SUSITNA HYDROELECTRIC PROJECT

FIRST SPECIALIST CONSULTANTS PANEL MEETING

REPORT ON MEETINGS

PRELIMINARY CROSS-SECTION
WATANA DAM - ROCKFILL
SUSITNA HEP
FEASIBILITY STUDY
OCTOBER, 1980

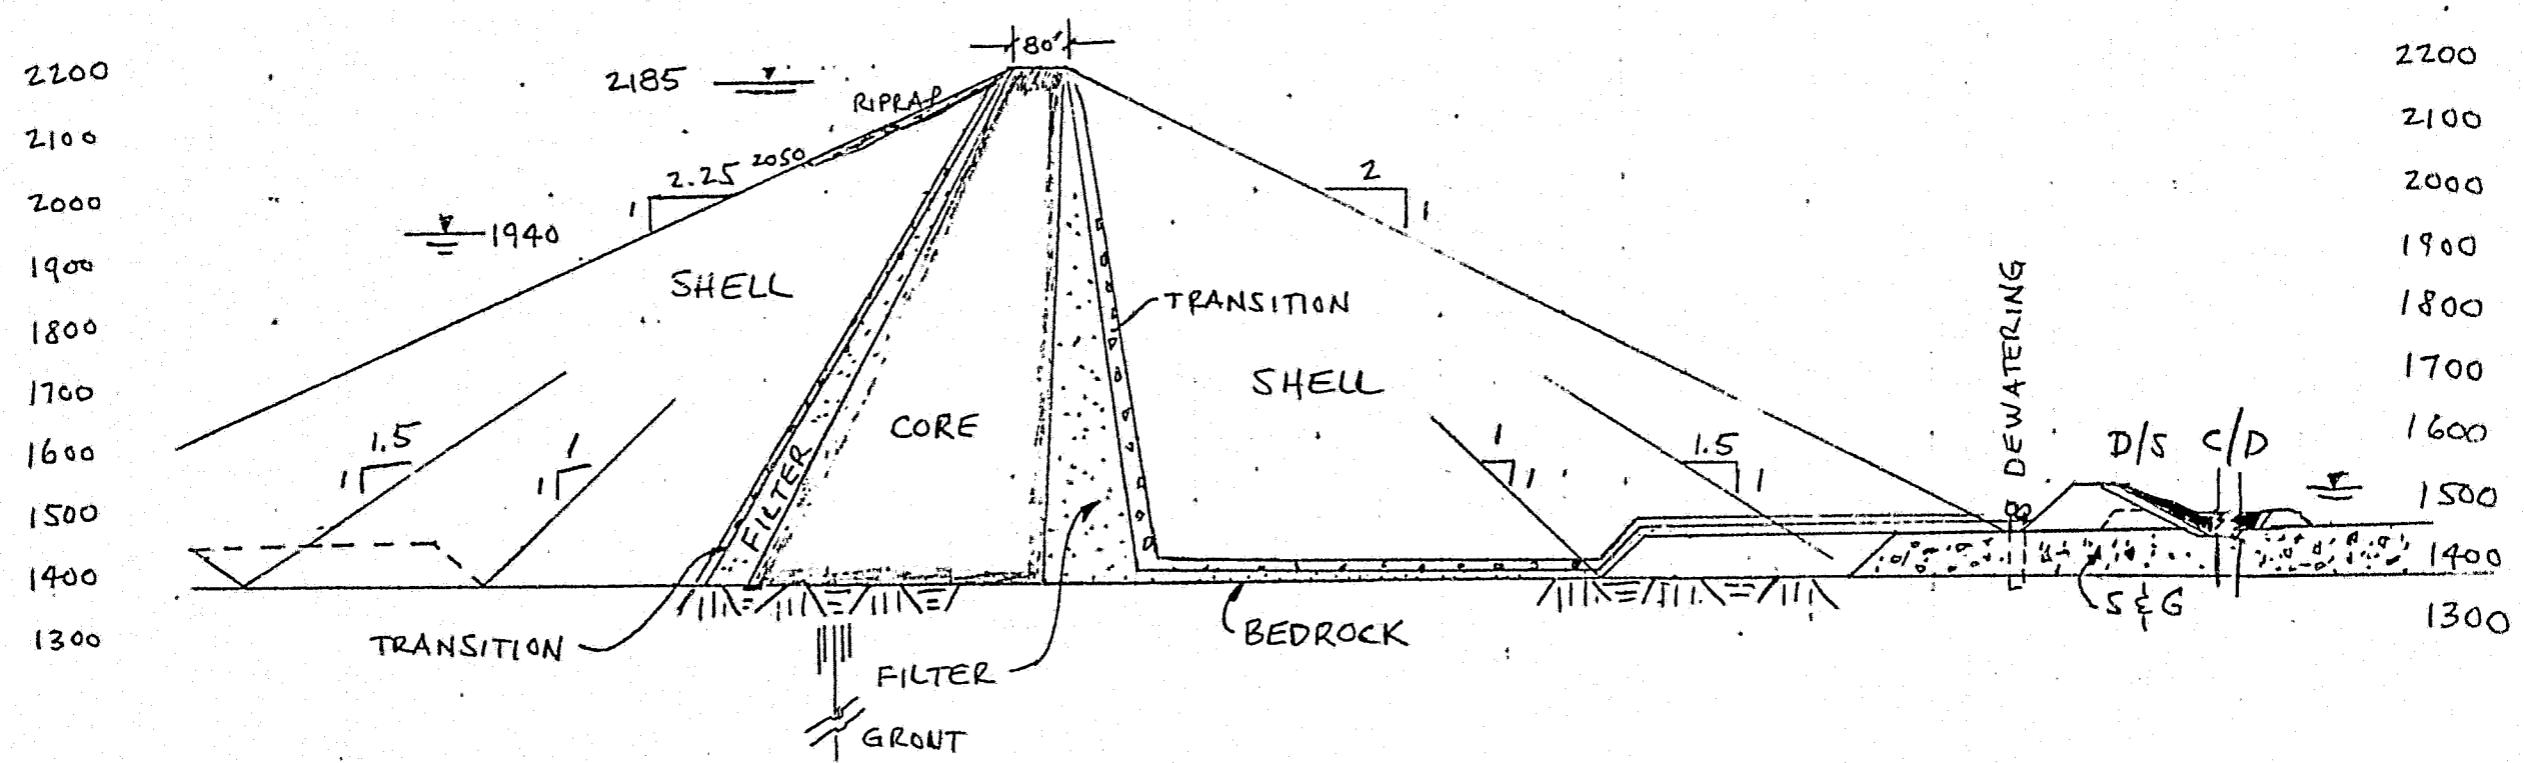
- A. Hendron - Question, Why downstream boundary of core is inclined slightly upstream.
- A. Tawil - There is a tendency towards tension in lower core if inclined downstream.

- R. Peck - Width and configuration of zones will be dependent on material properties.
- A. Hendron - With downstream slope on core - if shell settles it will tend to compress core, rather than place it in tension/

- R. Peck - Dependent on which settles most.
- J. Lawrence - Is there a need for grouting and drainage galleries? General agreement that they will be required.

- R. Peck - It is correct to assume (at this stage) that the material in the river channel should be removed.
 - Materials in dam should be selected for both static and dynamic behavior and then select where to use them in the dam.
